REVIEW NOTES
MIDDLEBURY RS 0174(8) - SAND HILL BRIDGE
PRECAST ABUTMENT FOOTING FABRICATION DRAWINGS
December 20, 2013

RE: Precast Abutment Footing Fabrication Drawings received from T Buck on 12/11/2013 (drawings dated 10/9/2013).

VHB Project No.: 57438.00

These notes accompany the review of the Precast Abutment Footing Fabrication Drawings reviewed by VHB on 12/20/2013.

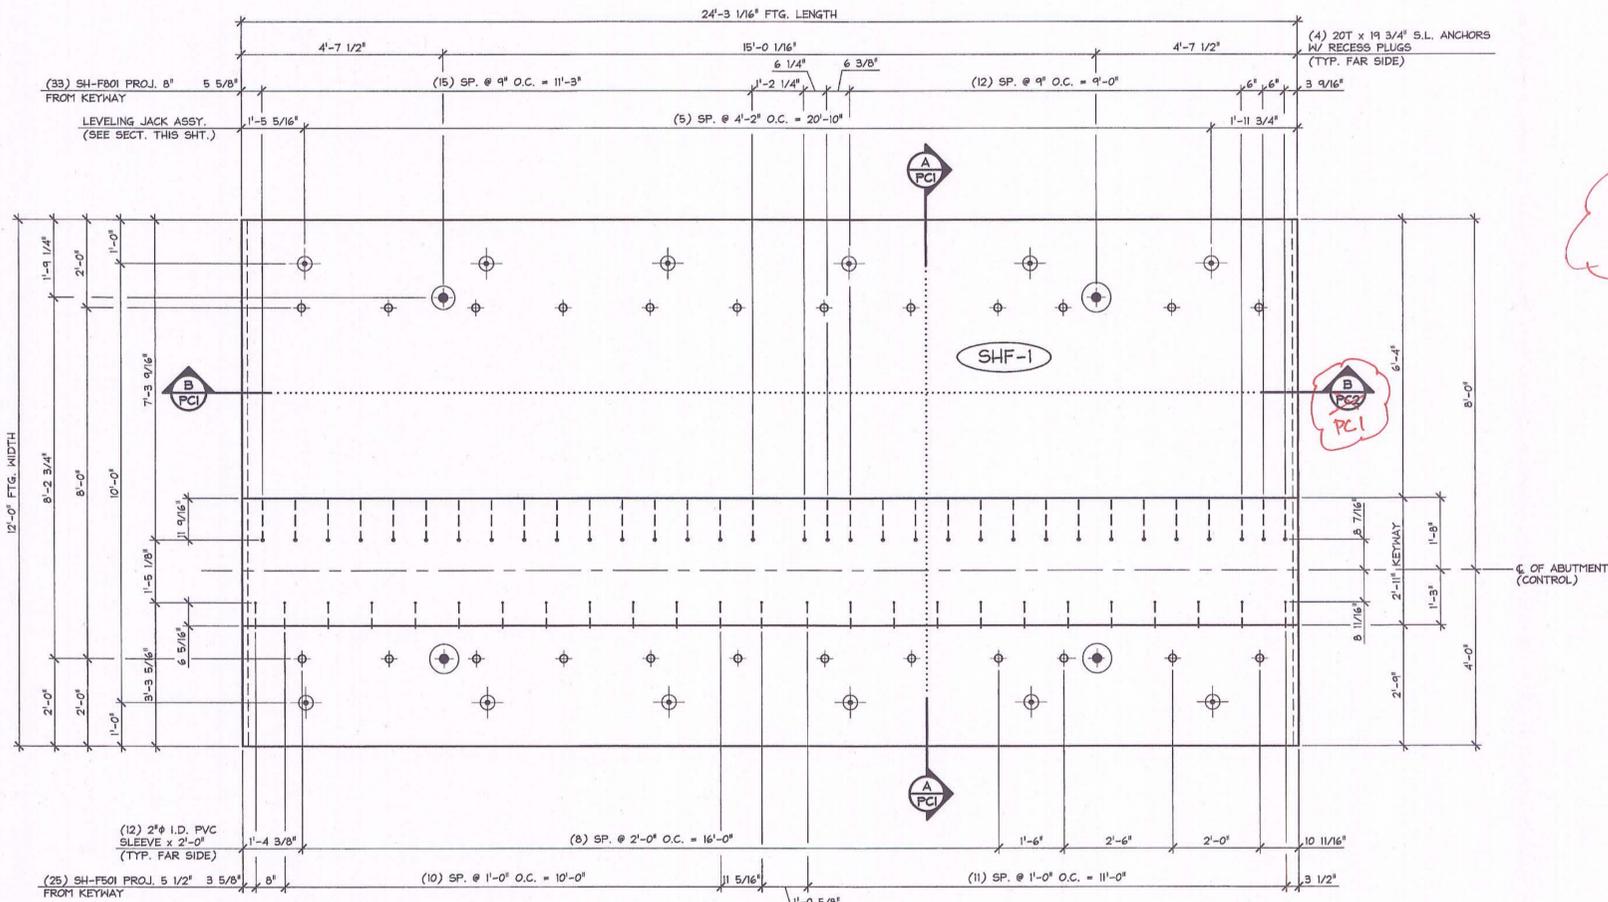
ADD REBAR SCHEDULE AND BAR BEND DIMENSIONS

LEVELING JACK SECTION
 3/4" = 1'-0"

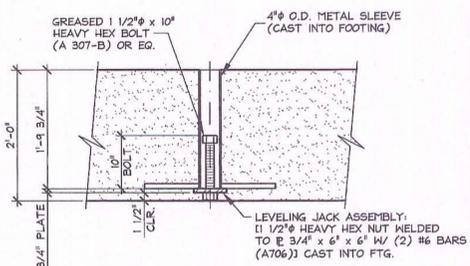
PLEASE PROVIDE PLAN VIEW OF LEVELING JACK ASSEMBLY

VERIFY LOCATION IN FOOTING

E REINFORCING DETAIL
 3/4" = 1'-0"

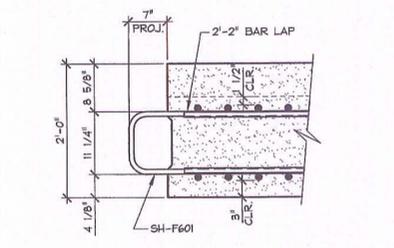
VERIFY

LEVELING JACK SECTION
3/4" = 1'-0"

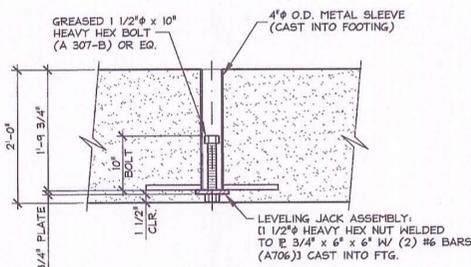
PLEASE PROVIDE PLAN VIEW OF LEVELING JACK ASSEMBLY

LEVELING JACK SECTION
3/4" = 1'-0"

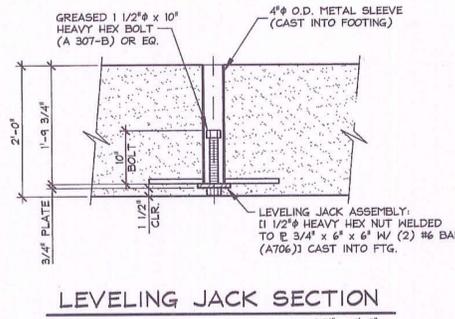
PLEASE PROVIDE PLAN VIEW OF LEVELING JACK ASSEMBLY

LEVELING JACK SECTION
3/4\"/>

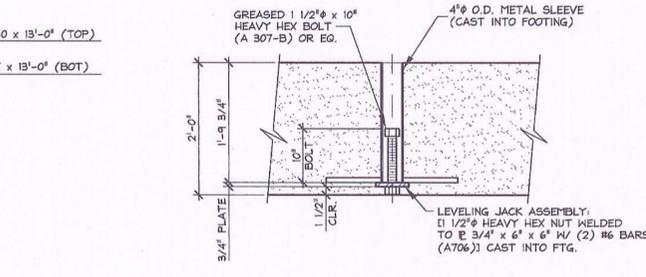
PLEASE PROVIDE PLAN VIEW OF LEVELING JACK ASSEMBLY

DATE: OCT. 9, 2013
SCALE: NOTED
CHKD: DFTM: T.D.
JOB NO: 23411-013
DWG. NO: PC7

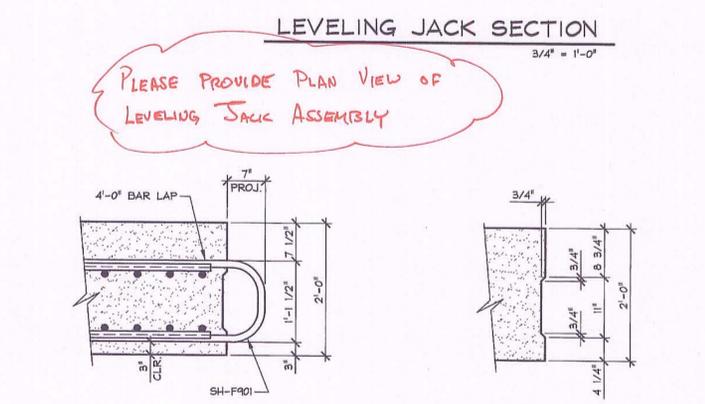
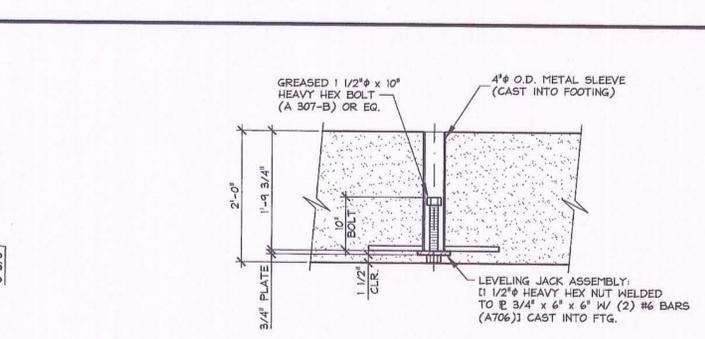
PLEASE PROVIDE PLAN VIEW OF LEVELING JACK ASSEMBLY
